POST CONSTRUCTION ROAD SAFETY AUDIT Island Bay Cycleway

Prepared for Wellington City Council

11 May 2016

Figure 2-3: Photo showing former pedestrian zebra crossing markings

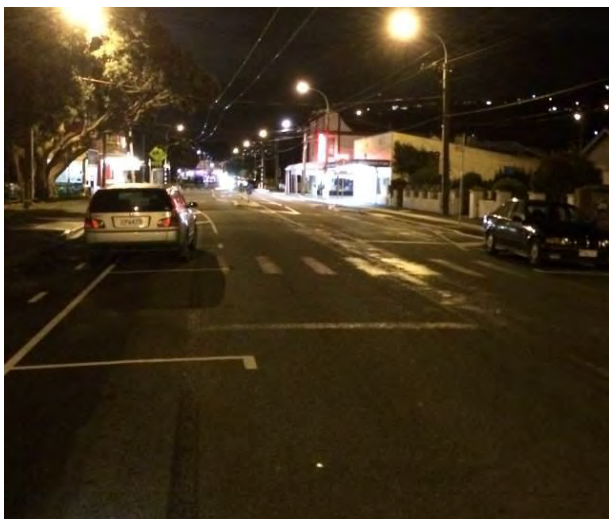
There are numerous locations throughout the project site where the previous markings have been blacked out using paint as opposed to other forms of removal. This causes confusion to the approaching motorist as it is not clear as to which markings are the correct markings as the blacked out markings can be clearly seen by approaching motorists (refer Figure 2-1 to Figure 2-4).

Figure 2-1 below shows that the right turn bay has been blacked out, but this is not immediately apparent from the approaching driver's perspective especially during the middle of the day when the sun shines along The Parade and at night with street light reflection off both the old and new road markings.

Remove redundant markings by a method that does not cause ghost marking such as a full width resurfacing.

Frequency	Severity	Rating
Crashes are likely to be Common	Death or serious injury is Likely	The safety concern is Significant
Designer response	The specification called for permanent removal of redundant markings. While it is acceptable to leave ghost markings in non-critical areas, permanent removal should be used to ensure unambiguous messages are given to road users in higher risk areas such as intersections.	
Safety engineer comment	N/A	
Client decision	Conflicting markings will be removed around intersections. Longitudinal markings will be left to wear away as blasting or blacking out has limited effectiveness on chip seal	
Action taken

Figure 2-7: Photo showing a lack of green coloured surfacing and cycle symbols across the Humber St Intersection

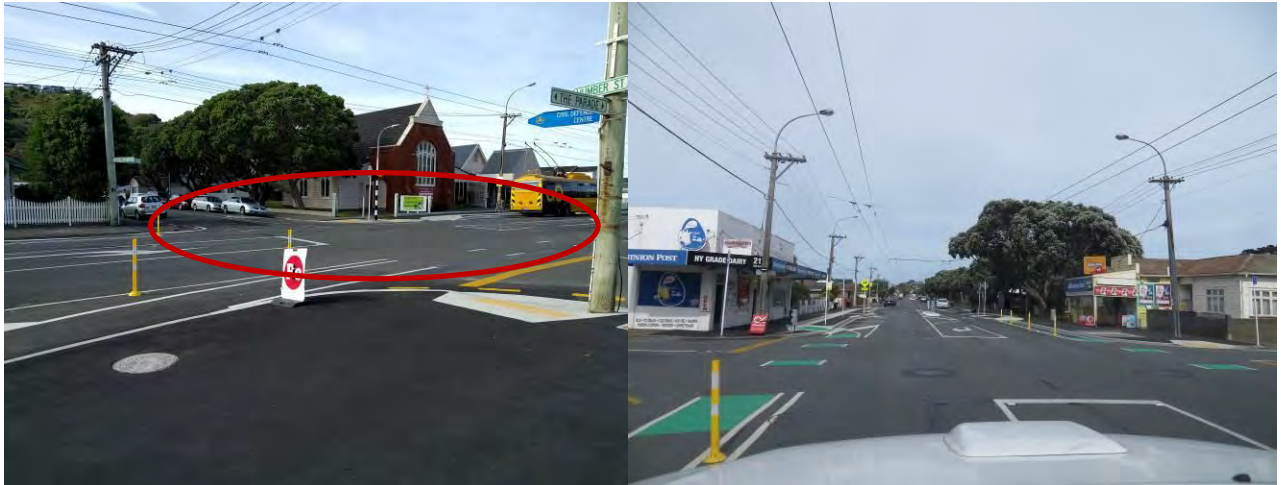
Green cycleway markings and cycle symbols are proposed at conflict areas between mode types. However, not all conflict areas and all hazard locations for cyclists have these markings provided (refer red circle in photos below). Intersection approach and departure chicanes should have this coloured surfacing to increase cyclists' awareness of the change in environment.

The SAT observed inconsistent application of both green coloured cycleway markings and cycle symbols along the bus stop cycle bypasses and across intersections, as shown in Figure 2-5 to Figure 2-8.

Ensure consistent application of green coloured cycleway markings and cycle symbols across the route, particularly at intersections and through both approach to and departure from the respective bus stop (and pedestrian refuge) bypasses.

Frequency		Severity	Rating
Crashes are likely to be Infrequent		Death or serious injury is Likely	The safety concern is Moderate
Designer response	Concur with safety audit.		
Safety engineer comment	N/A		
Client decision	The area shown in 2.5 is not a conflict area/safety issue, but using green to highlight the start of the bike lane is a good idea. Agree to install green as recommended by safety audit but cycle symbols will not be installed on all green markings as these will be used to raise awareness intimately throughout the route.		
Action taken

Figure 2-9: Photo showing the eastern Belisha beacon at the pedestrian zebra crossing opposite Empire Cinema was not operational

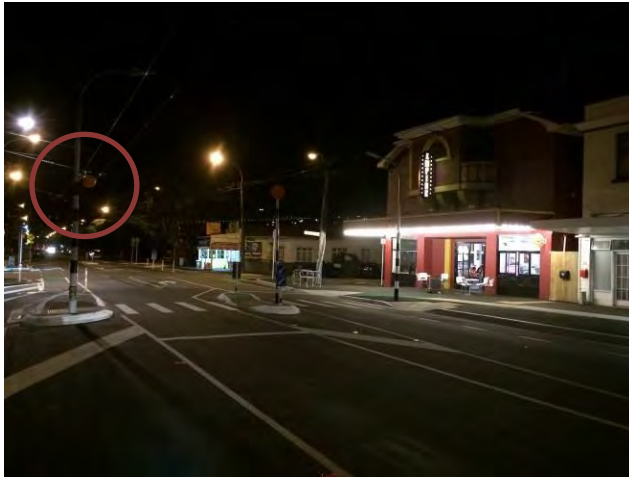
The SAT noted during the night inspection that a number of Belisha beacons at pedestrian crossings along the route were not operational, refer Figure 2-9 and Figure 2-10 below. Belisha beacons provide additional dynamic advance warning to approaching motorists of the presence of a pedestrian zebra crossing. It is important to ensure that where Belisha beacons are provided that they are operational.

Ensure that all Belisha beacons and floodlighting at pedestrian zebra crossings along the route are operational and replace or refresh (cleaning, change bulbs etc.) as required.

Frequency		Severity	Rating
Crashes are likely to be		Death or serious injury is	The safety concern is
Infrequent		Likely	Moderate
Designer response	Concur with safety audit.		
Safety engineer comment	N/A		
Client decision	Site checked 2 May 2016 – lights working. No further action required.		
Action taken	N/A

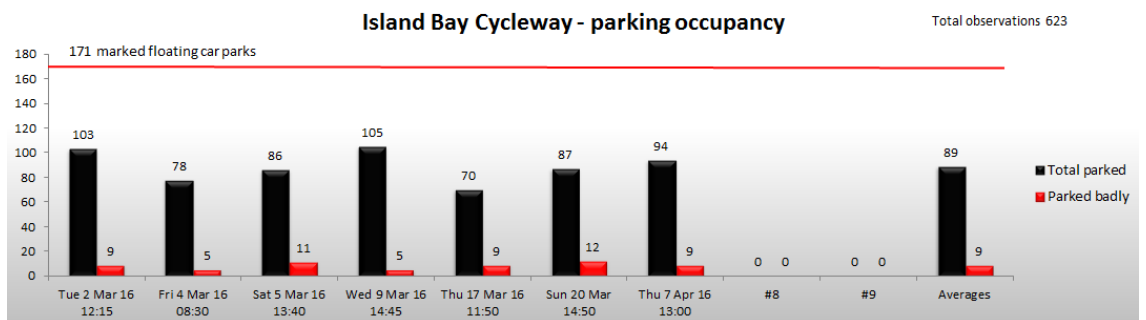
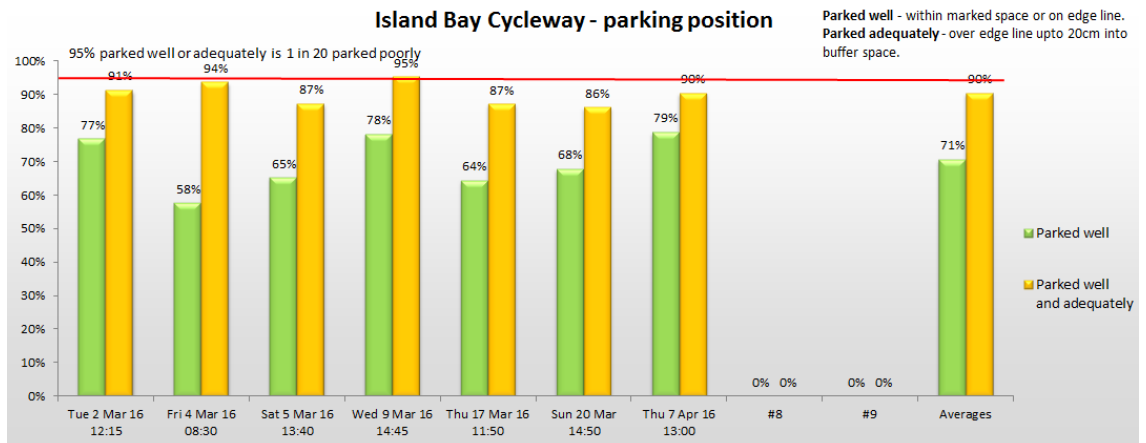
However, the SAT observed a number of vehicles parked well across the buffer zone, refer Figure 2-14 to Figure 2-17. Vehicles parked well across the buffer zone reduce the safety zone space increasing the risk of injuring a cyclist when passengers entering or exiting their vehicle open vehicle doors into the cycleway. Safe-hit posts (or other devices) installed on the corners of the respective parking bays aim to reinforce good parking behaviour to enable the safety zone space / buffer zone to be utilised by the open vehicle doors thereby minimising the likelihood of cyclist/vehicle door collision.

Provide appropriately delineated safe-hit posts (or other devices) at the corners of the individual parking spaces to increase parking compliance and reduce the likelihood of vehicle doors opening into the cycleway.

Designer response
 Concur with safety audit.

Client decision
 By 7 April 16 we had observed 623 parked vehicles over 7 surveys at various times and days of the week. The surveys showed 71% of vehicles were parked well and 90% parked well or adequately. Badly parked vehicles were observed to range from 5 to 12 with an average occurrence of 9.

To date there has been some education but little enforcement. We will instruct enforcement action to commence with a warning then infringement procedure. We will continue to monitor parking compliance and look to install safe hit posts if required.

Figure 2-19: Diagram indicating recommended parking exclusions around residential driveways adjacent to one-way separated cycle lanes (Source: “Finding the Right Green Road for Cycle Routes” – IPENZ Transportation Group Conference Paper, Auckland - March 2016).

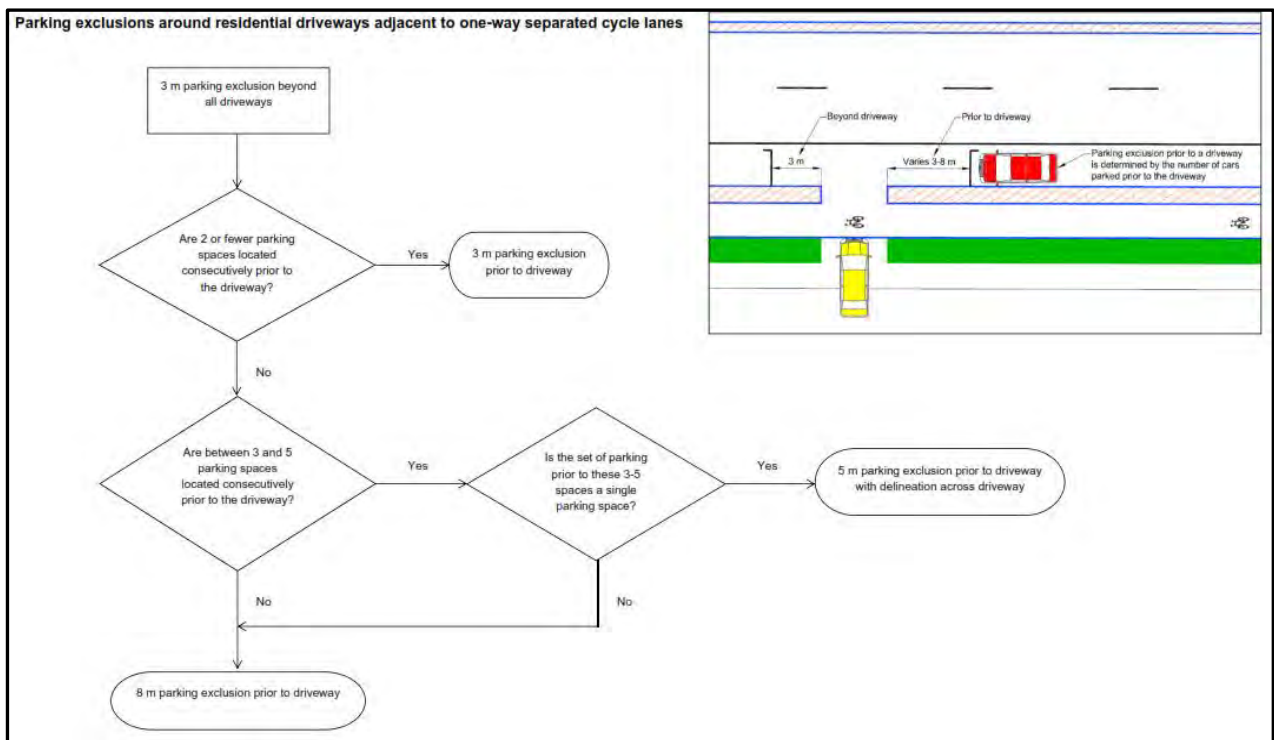
The SAT observed on site that a new residential driveway was being constructed at No. 84 The Parade directly opposite a marked parking space. The adjacent parking spaces upstream and downstream of this new driveway will need to be remarked appropriately in line with the guidance proposed in Figure 2-19 below.

It is recommended that a review of the marked parking spaces is undertaken along the route to ensure that appropriate spacing is provided either side of the driveways. This would provide both sufficient intervisibility between cyclists on the cycle lane and motorists entering and exiting driveways and appropriate manoeuvring space for motorists to carry out their turn movement without encroaching into the opposing traffic lane.

A recent paper from the *IPENZ Transportation Group Conference Auckland – March 2016*² proposed that a minimum 3m gap should be provided beyond the driveway (i.e. left hand side of driveways for exiting motorists). It was further proposed that the gap prior to the driveway (i.e. right hand side) varies between 3m to 8m depending on the number of vehicles parked prior to the driveway (refer to Figure 2-19 below).

Frequency	Severity	Rating
Crashes are likely to be Occasional	Death or serious injury is Likely	The safety concern is Moderate
Designer response	The design minimised on-street parking loss by applying the legal minimum of 1.0m space between driveways and the start of a car park in accordance with the client's direction.	
Safety engineer comment	N/A	
Client decision	From enquiries received as a result of construction it is felt that there are approximately 12-15 residents that would benefit from adjusting the parking adjacent to their driveway. We will work with these residents to resolve their individual issues over driveway access/egress	
Action taken

Figure 2-27: Photo showing missing tactile pavers at the central island of the refuge crossing south of Mersey St (inset photo: showing the kerb build out sitting outside of the markings)

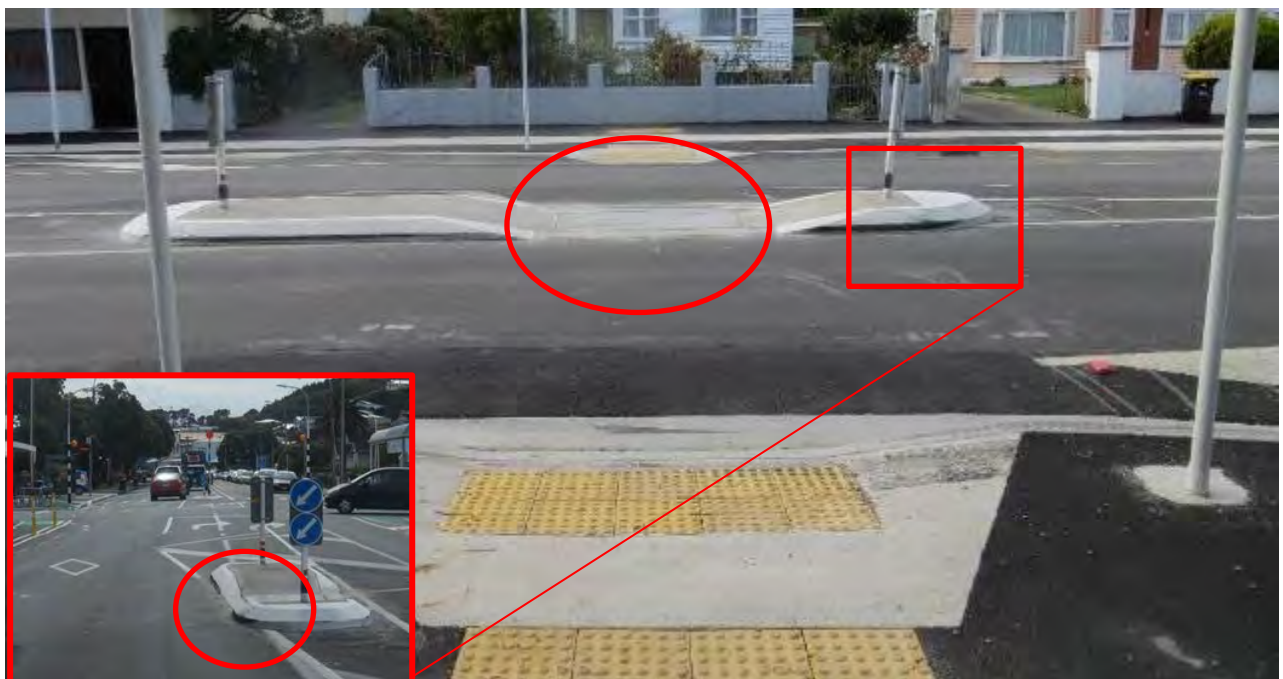
The SAT observed missing tactile pavers at the central island of the pedestrian refuge crossing point (refer Figure 2-27), this may result in visually impaired pedestrians failing to stop at the central island and continuing to cross The Parade, with the potential for vehicle conflict. These were included on the construction drawings but were not installed at the time of the audit site visit.

In addition, the SAT noted that the central kerb build out is sitting outside of the road markings and into the northbound traffic lane (refer Figure 2-27 inset photo). Scuff marks on the kerb confirm this hazard has previously been hit.

Frequency	Severity	Rating
Crashes are likely to be Occasional	Death or serious injury is Likely	The safety concern is Moderate
Designer response	The RTS 14 Guideline recommends no tactile pavers be installed in islands less than 1.2m wide. As this site is narrower, no further action is necessary. There is a need to alter the road markings (see 2-27) to ensure the island is appropriately delineated.	
Safety engineer comment	N/A	
Client decision	Agree with designer.	
Action taken
